**DEFENSE NUCLEAR FACILITIES
SAFETY BOARD**

Staff Report

Los Alamos National Laboratory Plutonium Facility Updated Leak Path Factor Analysis

Figure 1. Leak path factor methodology and software packages

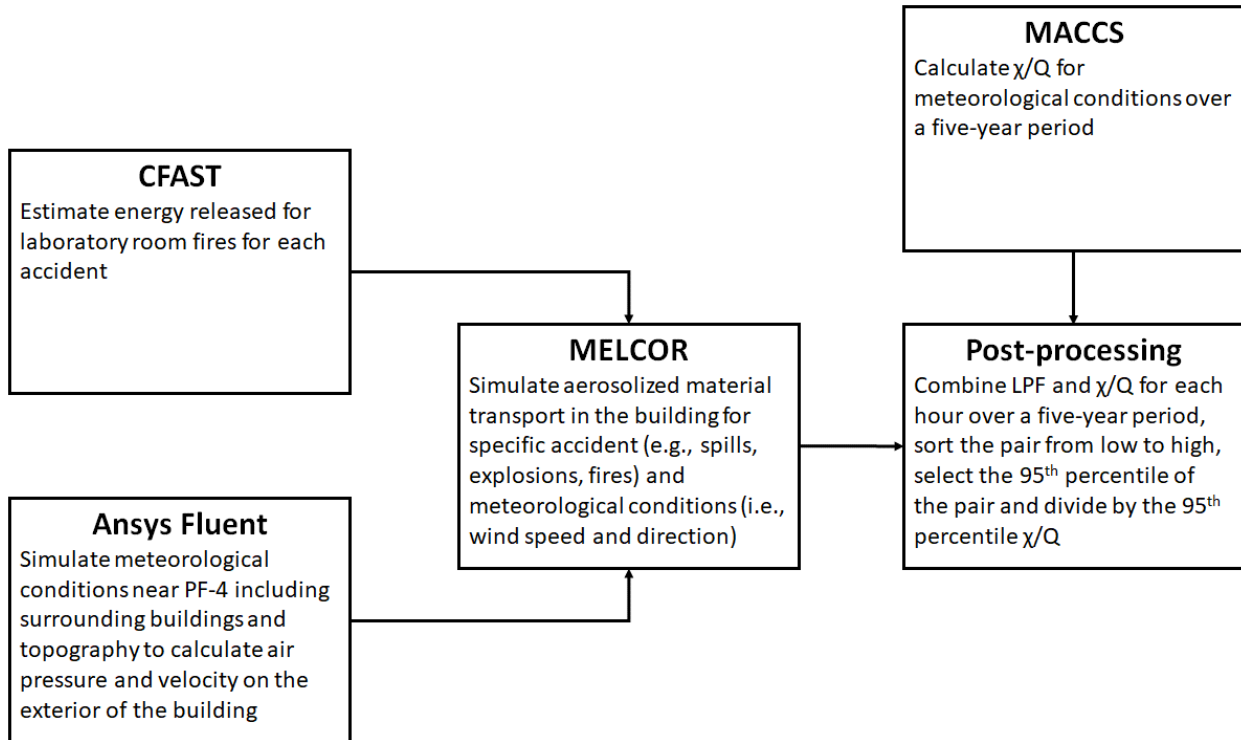
Based on the working papers and on discussions with Triad, the Board's staff found that the updated LPF methodology will have similar issues to the existing LPF methodology but will use different or updated software packages. The LPF methodology and software packages are described in Figure 1. Triad plans to use MELCOR version 2.2, which is newer than the version listed in the DOE Safety Software Central Registry¹ (version 1.8.5); Ansys Fluent release 19.0 (a

non- “toolbox” code); and CFAST version 7.1.1 (a “toolbox” code). For all safety software used, including software listed in the central registry, Triad personnel must ensure that the versions used meet software quality assurance requirements. The staff understands that Triad plans to provide supporting software quality assurance documentation for the code versions used in the final calculations.
